NOTICE

SW series

Changes to Product Design

SW-100S, SW-100B, SW-T100B

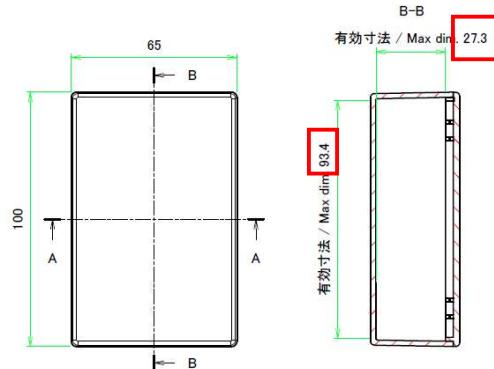
■ Change : Taper angles, Internal dimensions, Date stamp.

Previous design

Taper angle : 0.5°

New design

Taper angle : 1.0°

Date stamp example

■ The external dimensions are not affected by this change.
